Re: Preliminary Development Plan
#20151040078

Please see attached responses to your review letter dated 10-19-2015 for application #201510140078. Also be advised that we would like to change the name of the development From "Grove City Family Apartments" to "Southwest Apartments".

**SOUTHWESTERN APARTMENTS
PRELIMINARY DEVELOPMENT PLAN**
GROVE CITY, OHIO
DEVELOPER/CONTRACTOR:
L.W. ASSOCIATES, INC.
184 WEST MAIN STREET
ASHVILLE, OHIO 43103
740-983-4566
SCALE: - AS NOTED
DATE: 10/20/2015 SHEET: 1 OF 3

<p>SOUTHWESTERN APARTMENTS FIRE TRUCK TURNING RADIUS PLAN GROVE CITY, OHIO</p>	
<p>DEVELOPER/CONTRACTOR: L.W. ASSOCIATES, INC. 184 WEST MAIN STREET ASHVILLE, OHIO 43103 740-983-4566</p>	
<p>SCALE: - AS NOTED</p>	<p>DATE: OCTOBER, 2015</p>
<p>SHEET: 1 OF 1</p>

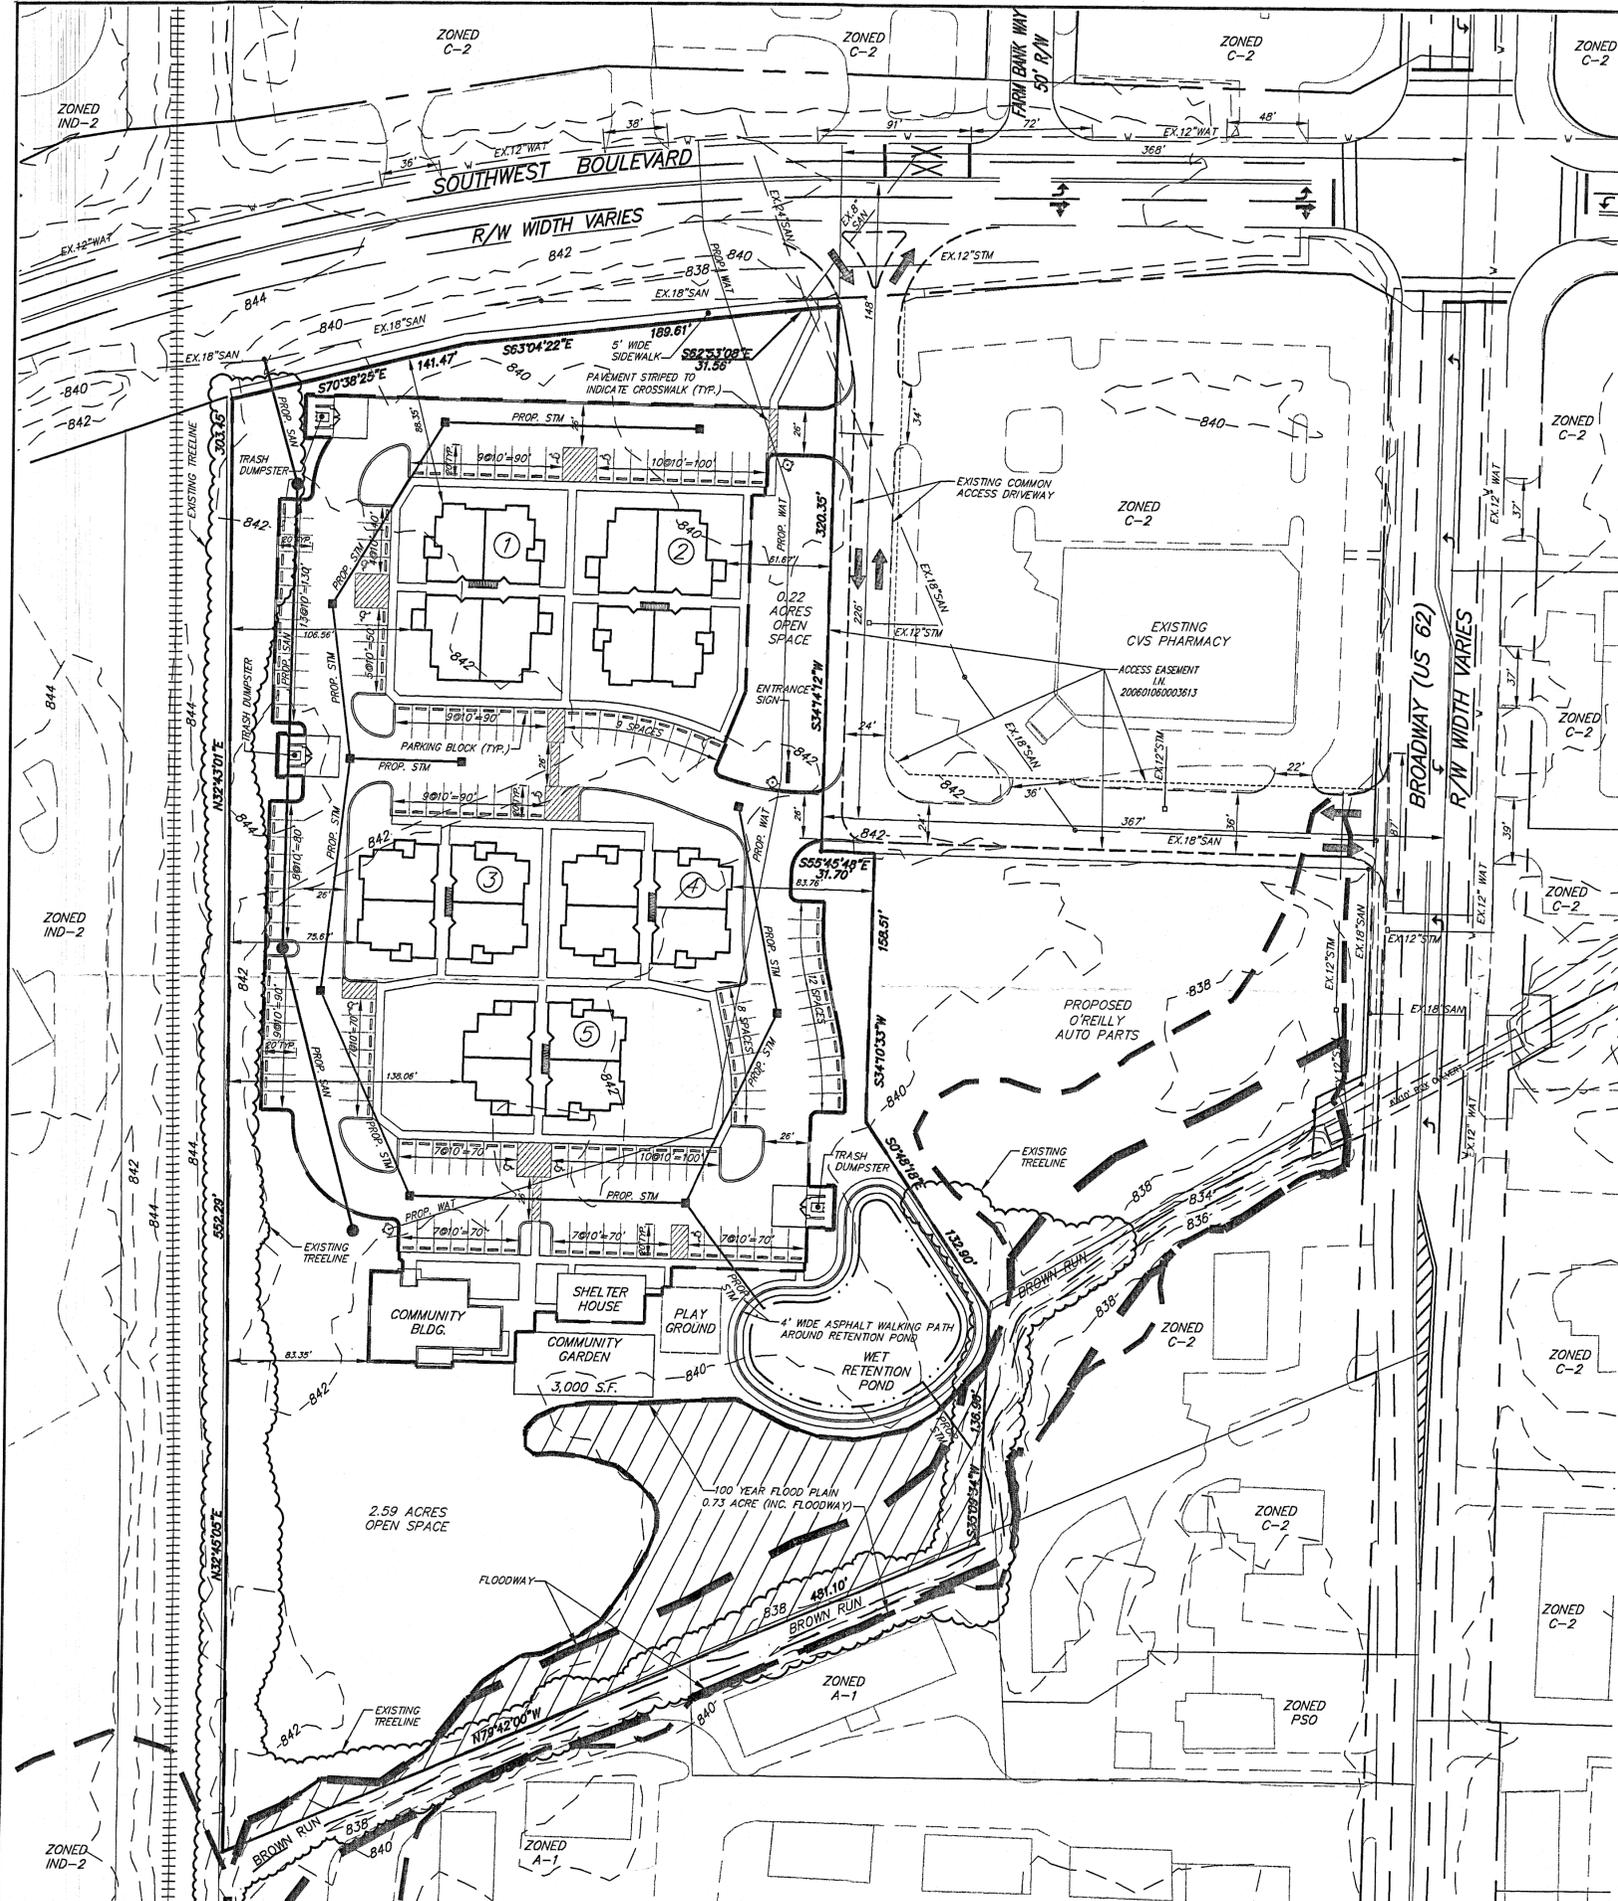
30. Applicant needs to show details on how the Jackson Township Fire Department ladder truck can access and maneuver the site.

Please see attached Auto Trun Plan Exhibit

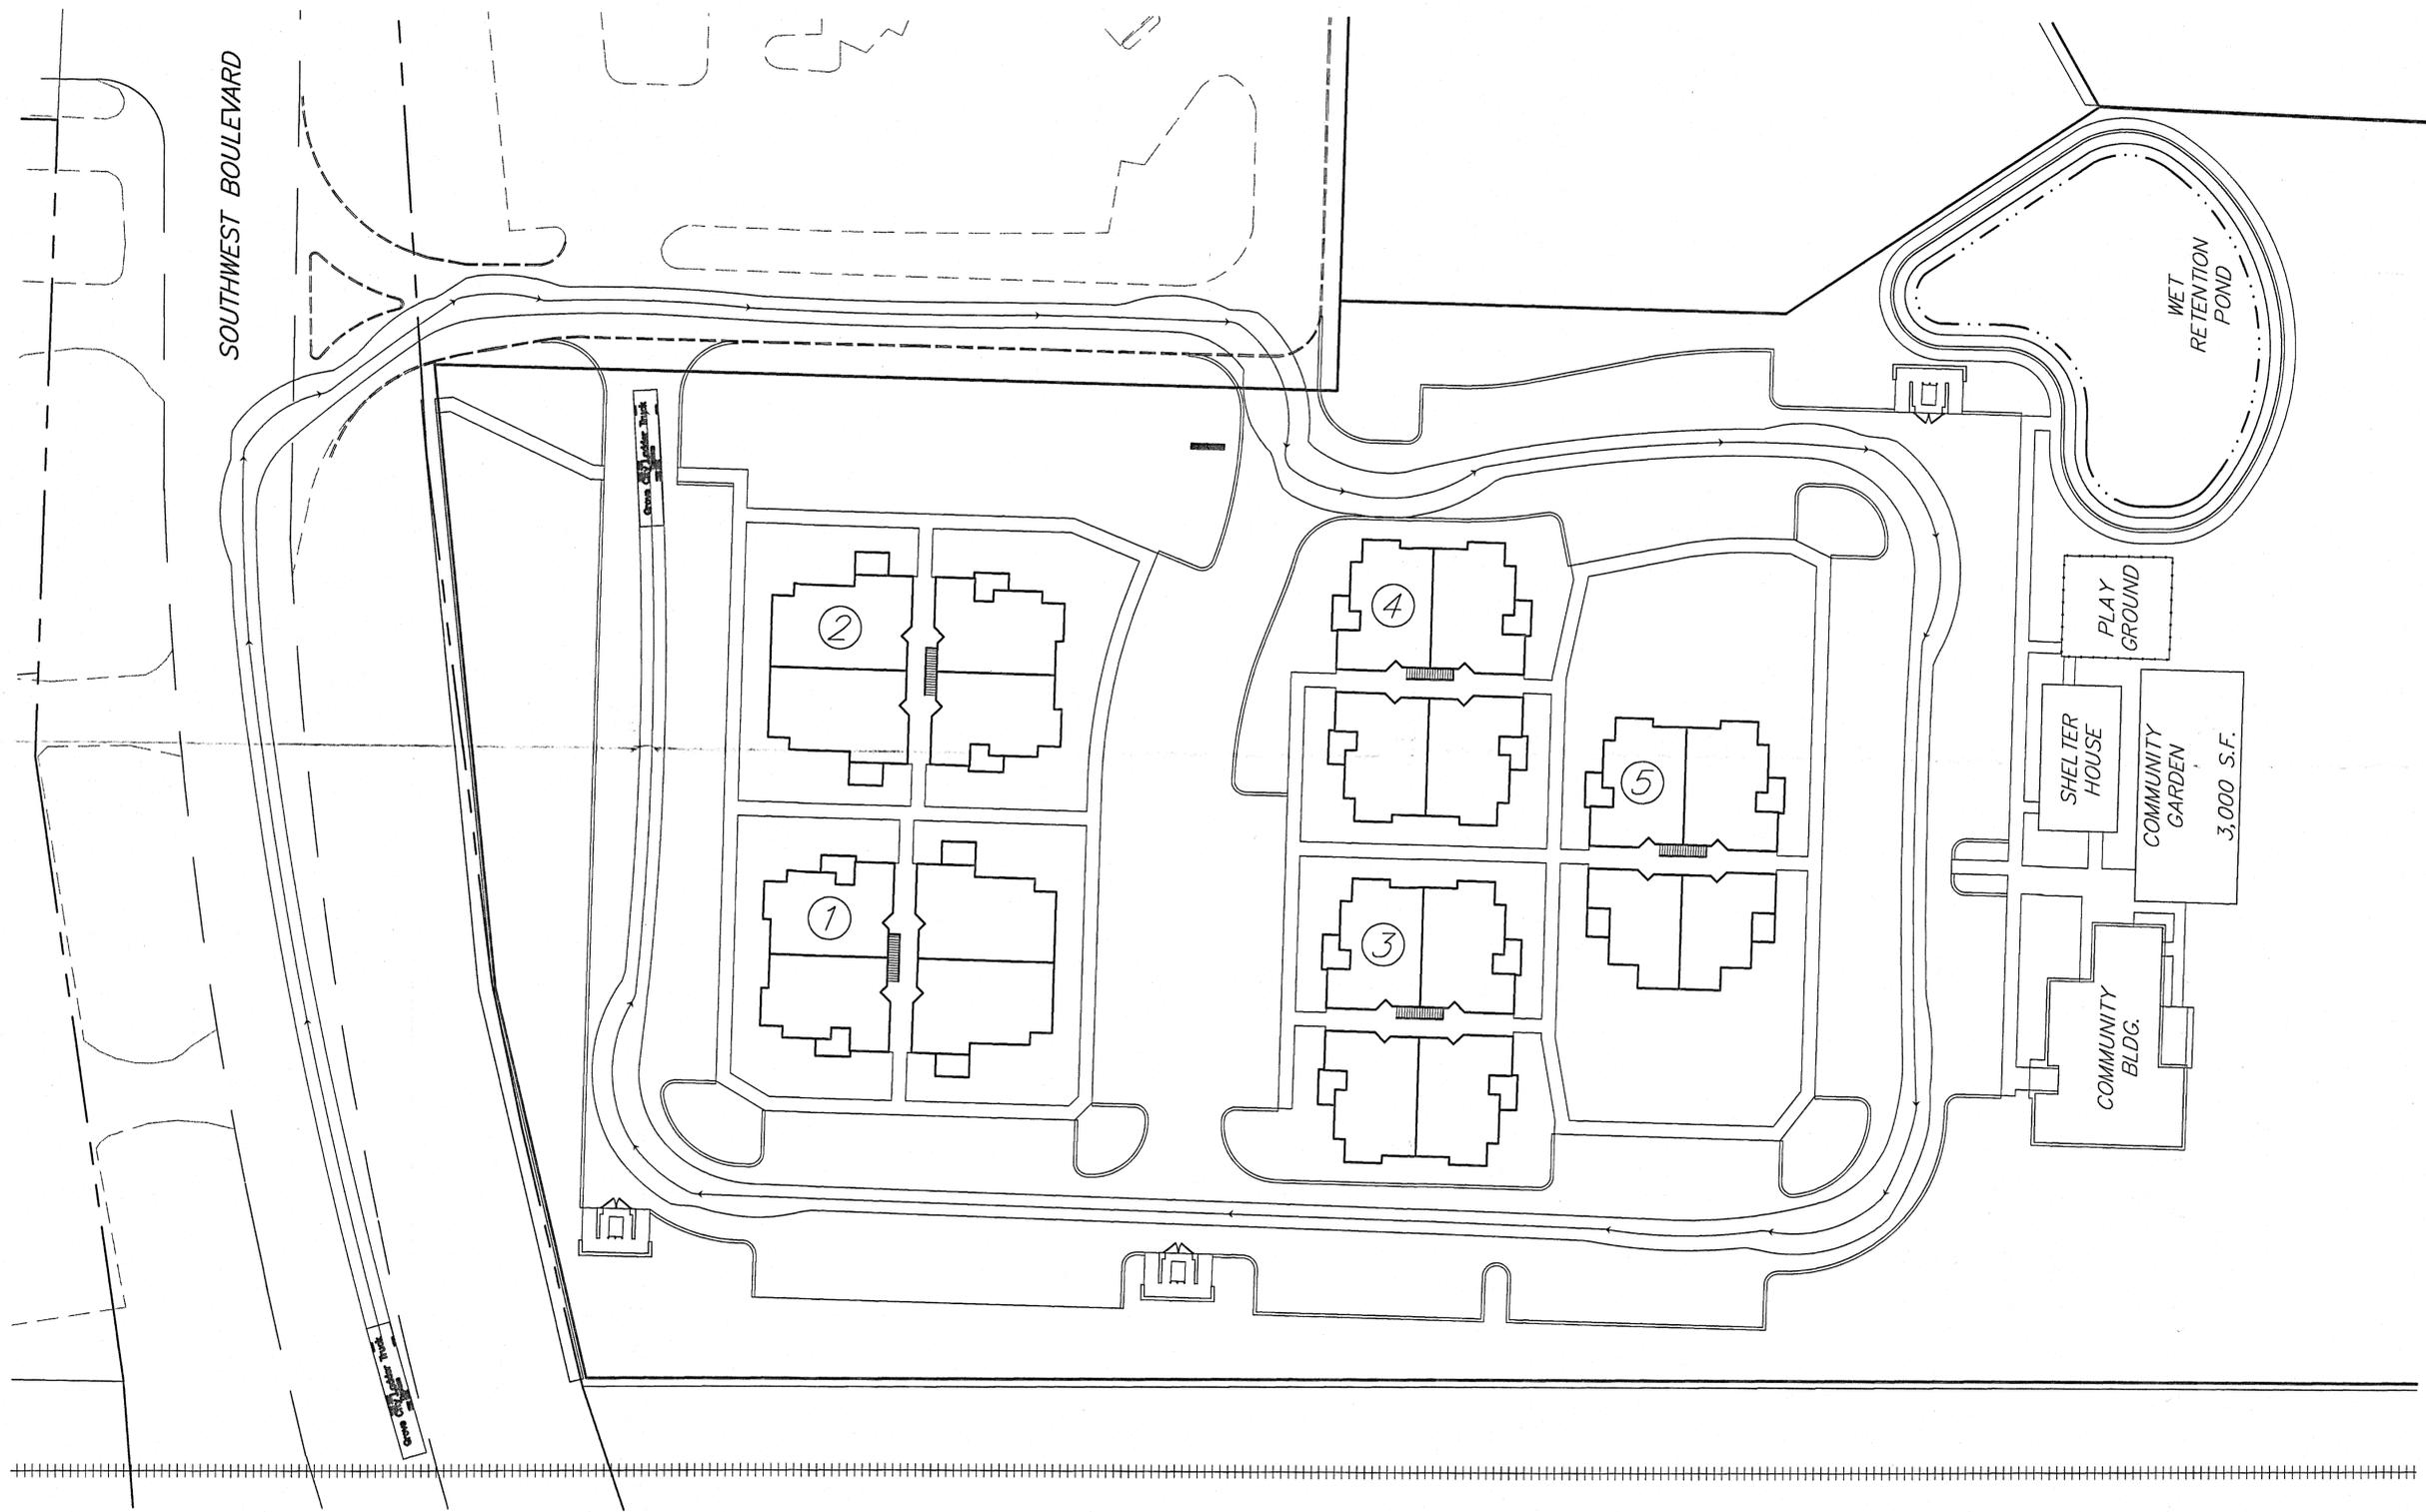
2. The southern entrance drive should be realigned to create a straight extension from the existing CVS shared drive. Buildings and parking lots should be reconfigured to accommodate this realignment.

5. Based on the number of units proposed (60), 2.69 acres of open space is required for this development. Open space should be delineated on plans and the total amount of open space proposed should be noted in the Site Tabulation.

6. The sidewalk along Southwest Boulevard should be extended with this project and shown as such on plans. The existing sidewalk between CVS and Southwest Boulevard should be shown on plans.

8. Parking rows containing more than 21 consecutive parking spaces require a landscape island or peninsula to break up the row of parking. The southern-most parking row (adjacent to the community building and playground) currently contains 23 parking spaces. Staff recommends a large landscape area with sidewalk be installed across from the sidewalk between the apartments to the north to continue the pedestrian corridor (noted in comment #7).

9. A walking path should be installed around the proposed storm water pond.

Drive has been aligned as well as the parking areas.

Please see open space tabulation which is now located on the plan.

Sidewalk along Southwest Blvd has been add as well as the existing walk along Southwest Blvd on the CVS property.

Landscape Island has been added to the plan as requested.

Walking path is noted around the pond.
